1. AGENCY USE ONLY (Leave blank)		2. REPORT DATE 04/00/87		3. REPORT TYPE AND DATES COVERED	
4. TITLE AND SUBTITLE CONTAMINATION ASSESSMENT REPORT, PHASE I, SITE 36-8, CHEMICAL DRAINAGE DITCH, TASK 1, SECTION 36, FINAL, VERSION 3.2				5. FUNDING NUMBERS  DAAK11 84 D 0016

FINAL PHASE I  
CONTAMINATION ASSESSMENT REPORT  
SITE 36-8: CHEMICAL DRAINAGE DITCH

April 1987  
Contract Number DAAK11-84-D0016  
Task Number 1 (Section 36)  
(Version 3.2)

Figure 36-8-3  
REGIONAL TOPOGRAPHY  
SITE 36-8  
ROCKY MOUNTAIN ARSENAL

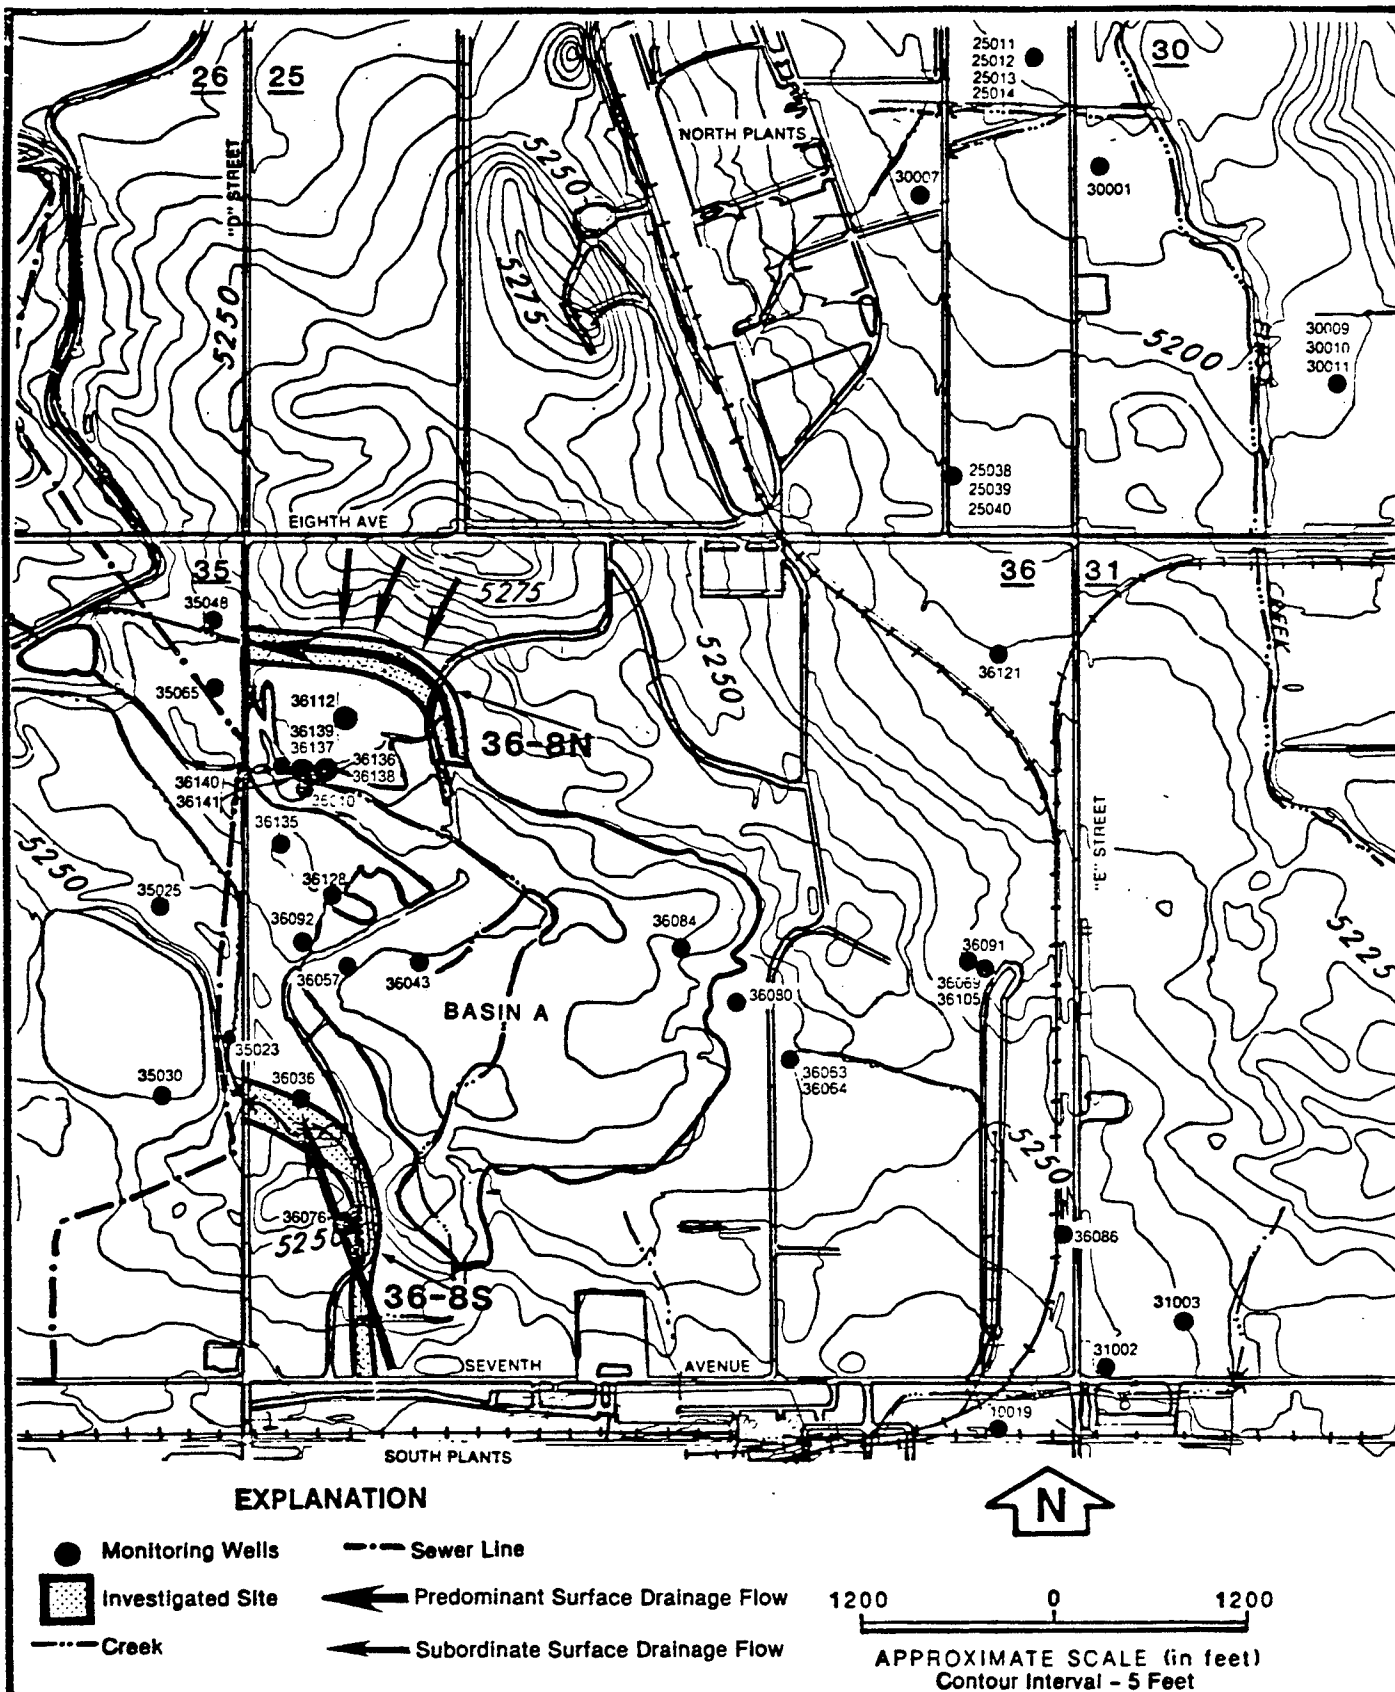
1. P.36-8-17 The monitoring well #1 location on this figure doesn't correlate with Figure 36-5-6. All monitoring wells need to be labeled.
2. P.36-8-17 Previous ground water data collected in 1979, 1983, and 1984 show substantial DBCP contamination (195 ppb) at well #1 and volatile organic contamination at well #76 yet soil samples were not collected in the vicinity of this known contamination. Phase II analytic program sampling should be conducted into the uppermost ground water system in these areas for volatiles and DBCP.

1. P.36-8-17           The monitoring well locations shown on the figures were incorrect in the previous report draft. A new Figure 36-8-3 has been included and shows the correct locations and numbers for relevant wells.

Figure 36-8-6b  
 SITE 36-8N, PHASE I INVESTIGATION  
 CHEMICAL ANALYSIS RESULTS

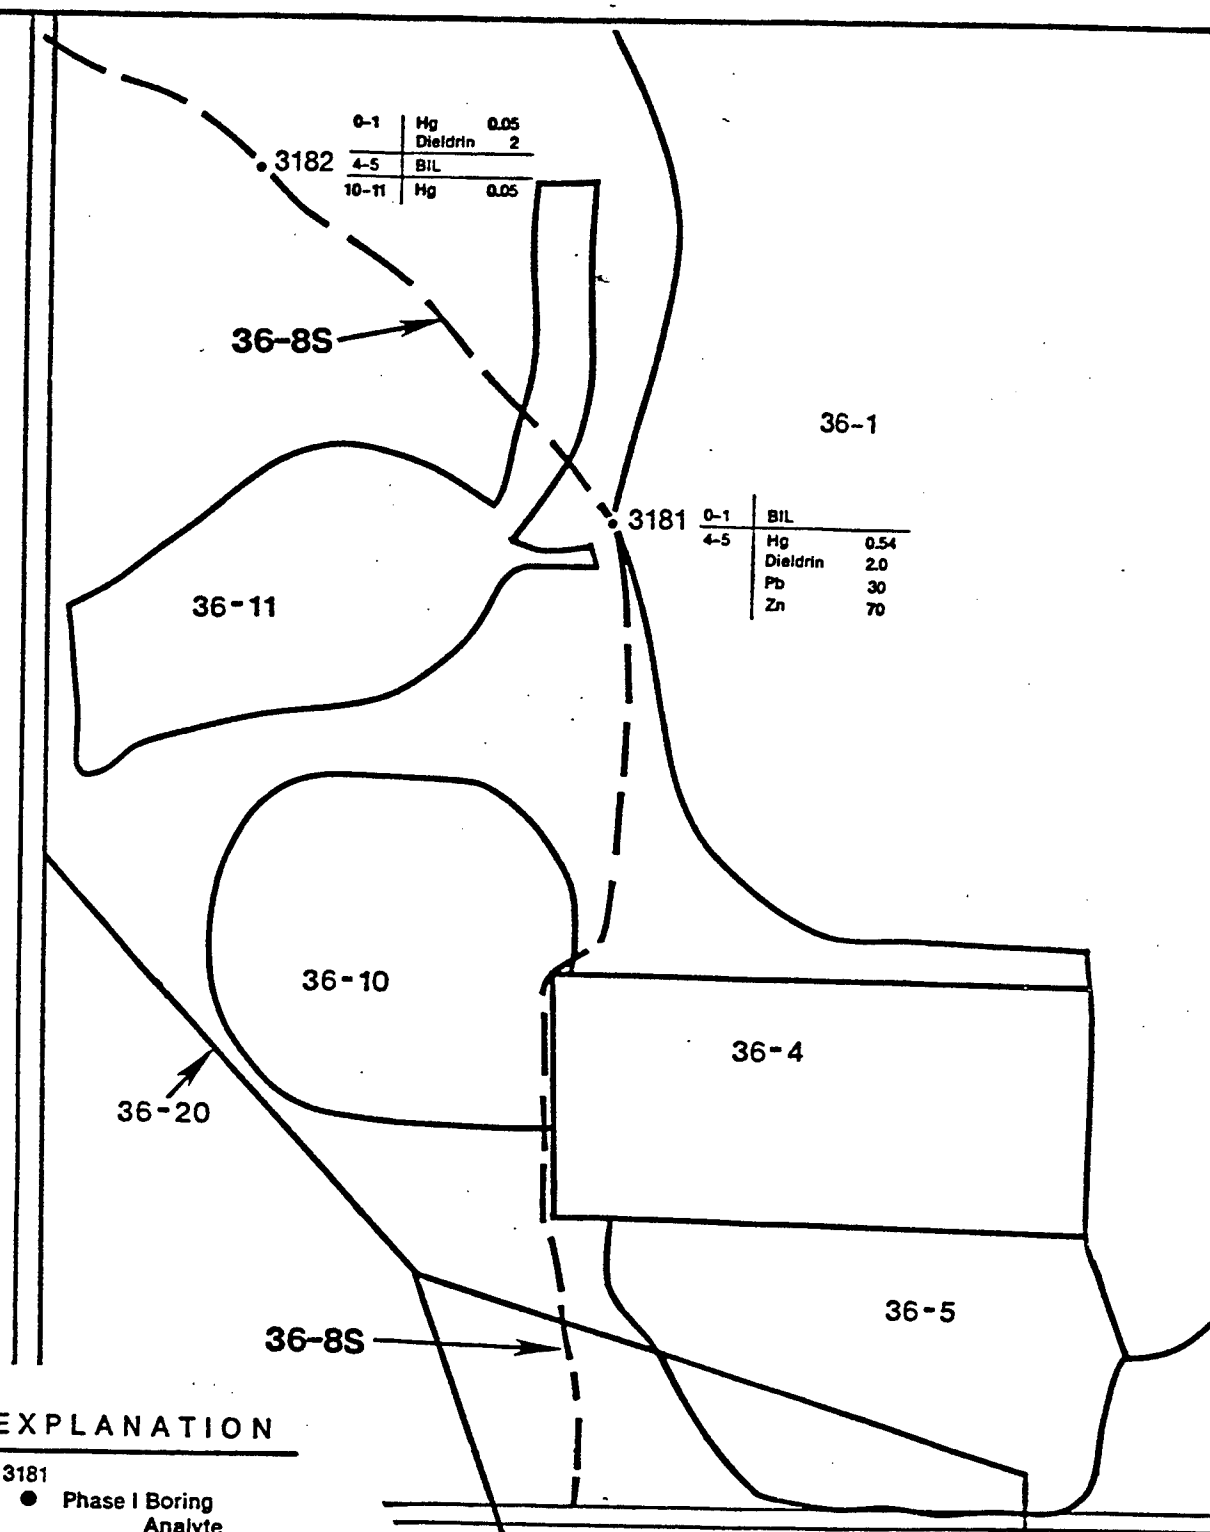
1. Figure 36-8-6B. Why is a transect made at boring 3053 (which was originally in an "uncontaminated" area) when boring 3183 nearby has substantially greater contamination?

1. Figure 36-8-6B. Transects were placed to provide data at the upstream and downstream ends of the ditch which would help define alignment and lateral influence. In this case, symmetry was not assumed, partially because the exact alignment of the ditch is not defined. The boring arrangement shown is thought to be the most economical given site conditions and the questions we are trying to answer.

Figure 36-8-6a  
SITE 36-8S, PHASE I INVESTIGATION  
CHEMICAL ANALYSIS RESULTS

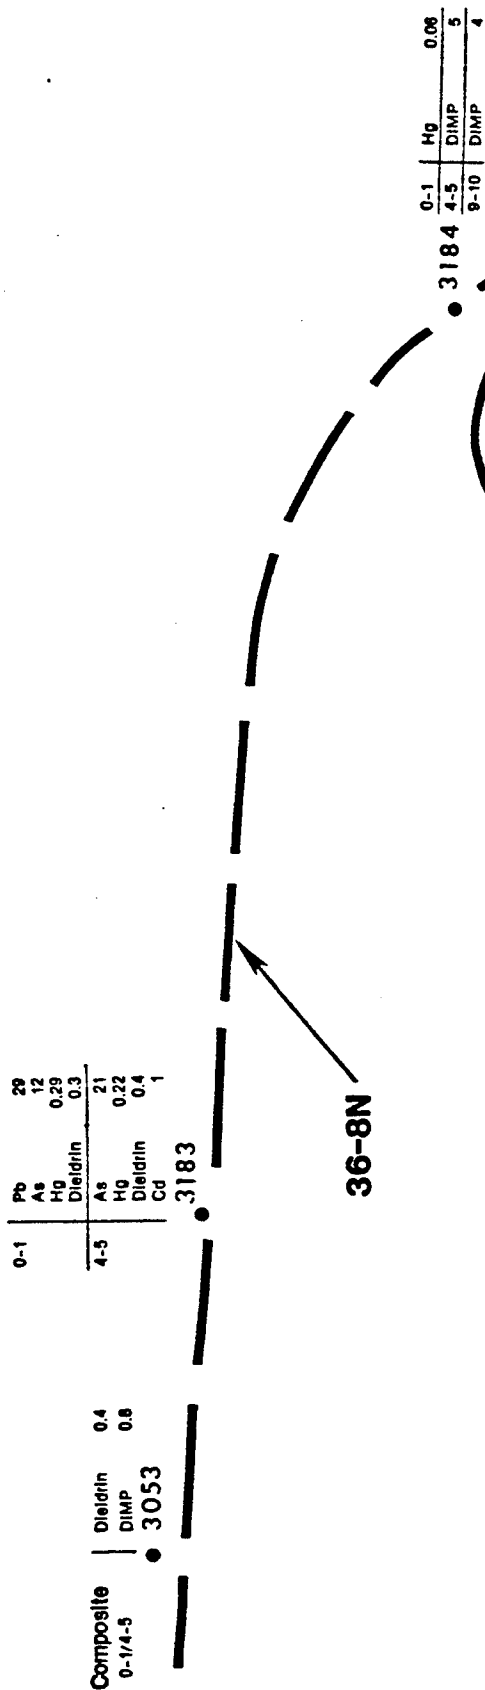
Figure 36-8-6a and Shell Comment No. 2 on Site 36-8 Draft Final CAR. The Army asserts that the "undocumented line" (see 36-20 Task 1, page 9) is being investigated as a part of Task 10. This line was not originally a part of Task 10, and no formal proposal to add this work to Task 10 has ever been received for review. Shell requests that Army provide the relevant documentation for review.

Figure 36-8-7b  
SITE 36-8N, PROPOSED  
PHASE II INVESTIGATION

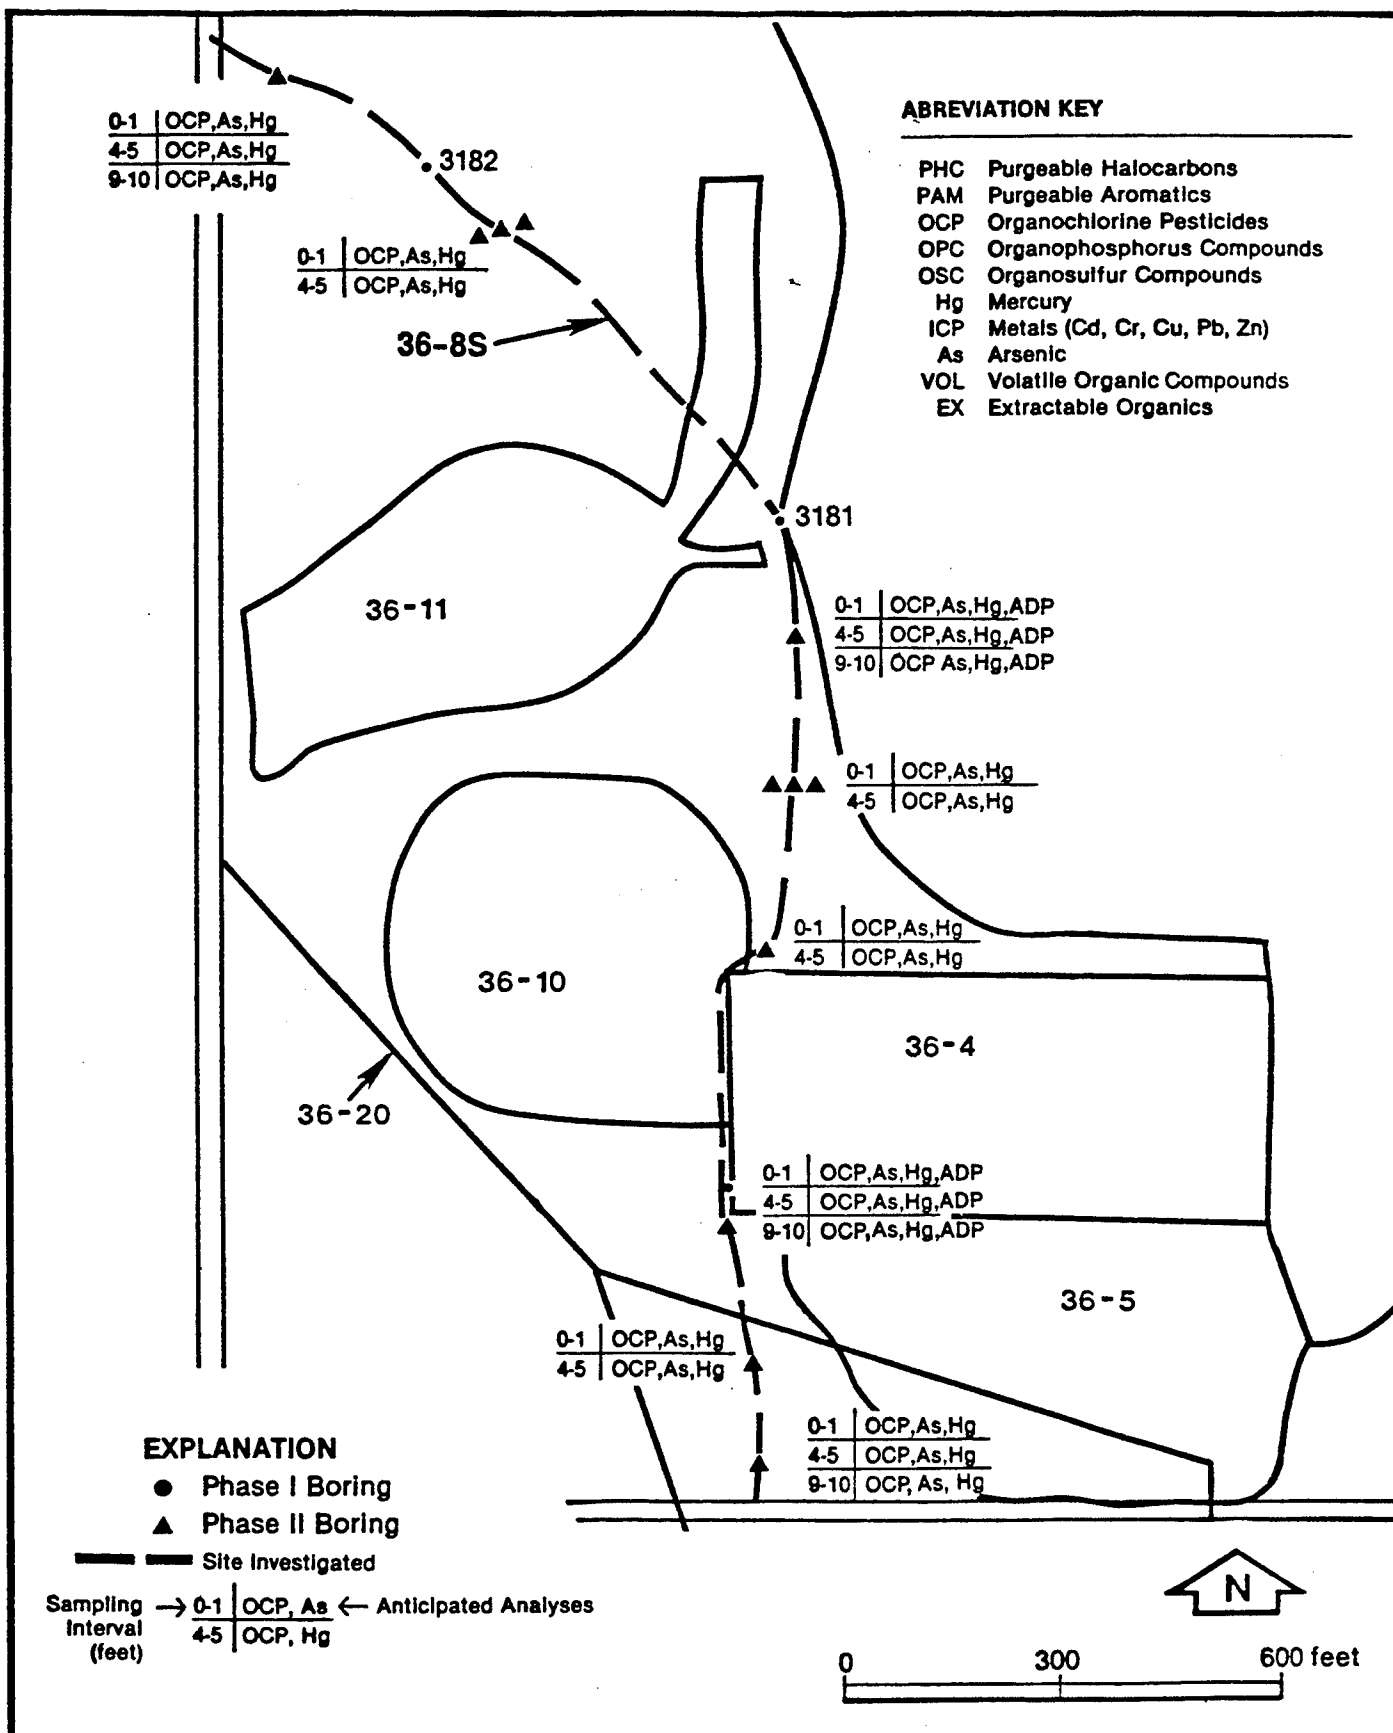
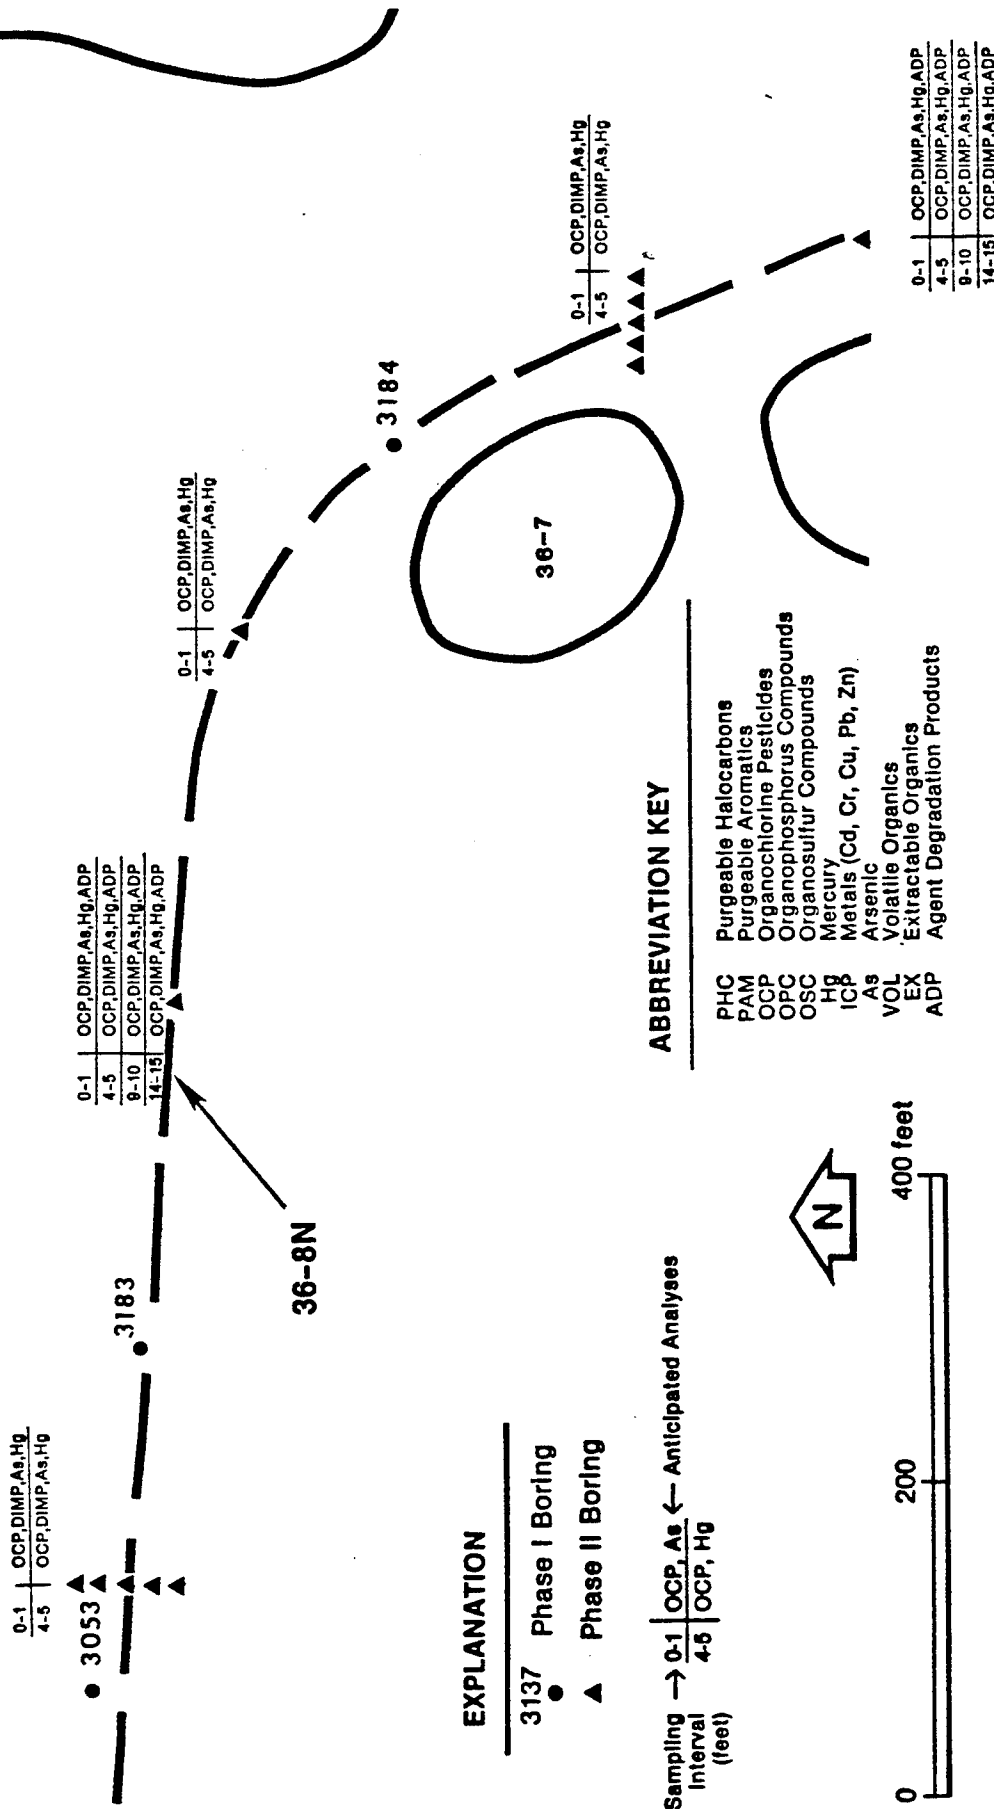
2. Figure 36-8-7. Boring 3185 should be on this figure. Borings should be placed around 3185.
3. Figure 36-5-1. Volatile analyses are done on all sample intervals except A in source areas 36-8 and 36-20 and on C level (or deepest) in 36-5, 36-10 and 36-12. What are the criteria for deciding which sample interval will be analyzed for volatiles?
4. 36-8-9. Will contamination above or in the gray lime cake be investigated?
5. Table 36-8-5. Wells listed are not identified in Figure 36-8-5a.
6. 36-8-19, first paragraph The suggestion that the contaminants are derived from disposal activities associated with source 36-8 may be true provided fluctuation of the ground water table does not exceed a couple of feet.

2. Figure 36-8-7. Boring 3185 was part of the 36-20 investigation and was mislocated in the field, off the 36-20 alignment. Phase II borings for Site 36-20 are located in this vicinity. Boring 3185 is influenced by an abandoned sewer line nearby, which is being investigated under Task 10.
